Access Compliance Report Public Rights-of-Way (Curb Ramps)

Main Street: CASTLETREE Cross Street: WOODSONG Location: N

ADA ID: RPRK211018145113 Ramp Type: Type 1 - Perpendicular Diagonal Initial Pass/Fail: Fail Overall Compliance: No Severity Score: 15

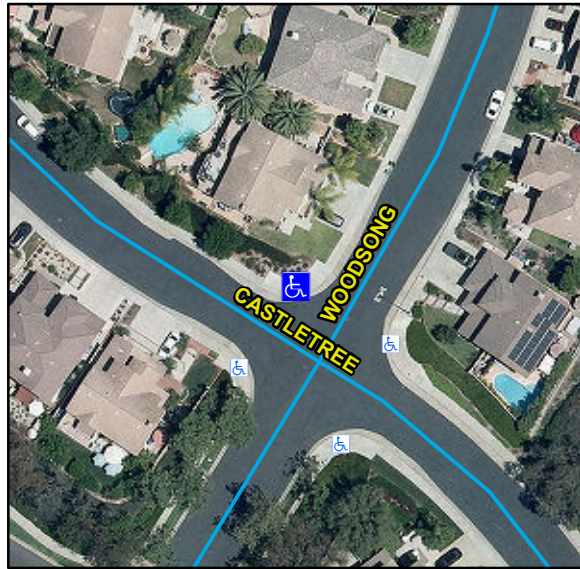
R204.3, R304.2.2, R302.7.2, STD 1115

Remove & Replace Curb Ramp With Two New Directional Ramps or Equivalent. Grind Gutter Lip.
